BEFORE THE BOARD OF PATENT APPEALS  
AND INTERFERENCES

Application Number: 10/783,548  
Filing Date: February 20, 2004  
Appellant(s): FOREST ET AL.

**EXAMINER'S ANSWER**

FIG. 3

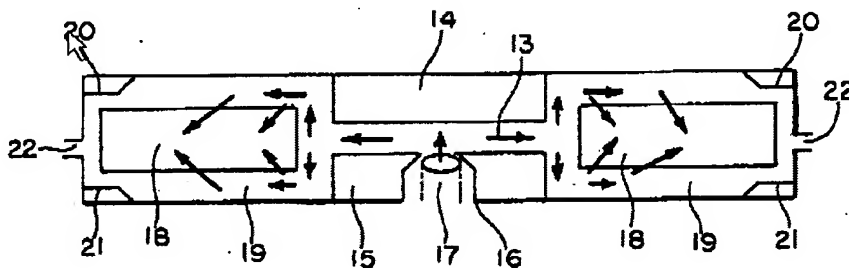
Regarding which molds of Wood are modified by the combination, the examiner notes that the Figure 3 and Figure 10 molds of Wood are the molds employed by the examiner as the molds most obvious to modify with the teaching of Johnson. Appellant has referenced and included a copy of Figure 4 from Wood. While the examiner submits that modifying the mold of Figure 4 would also be obvious in view of the teaching of Johnson, this is not the mold the examiner has proposed to modify.

Referring to Figure 3 from Wood, it is noted that preforms (18) are in the process of being embedded with resin or pitch entering through one port/gate (17). Referring to Figure 10, a stacked configuration is shown wherein a plurality of preforms are being embedded with resin or pitch through one port/gate (54).

notes that it should be remembered that the arrows in Figure 3 and Figure 10 of Wood are showing the movement of a highly viscous and rapidly densifying resin or pitch material as it is embedding fibrous preforms (i.e. resin transfer molding process).

Accordingly, the examiner submits that one having ordinary skill in the art at the time of the claimed invention, in view of the teaching of Johnson to provide multiple inlet ports, would have found it obvious to have modified, for example, either Figure 3 or Figure 10 of Wood, by providing a plurality of inlets in both the top and bottom portions of the mold for the purpose of reducing the flow distances of Wood's highly viscous and rapidly densifying resin or pitch material.
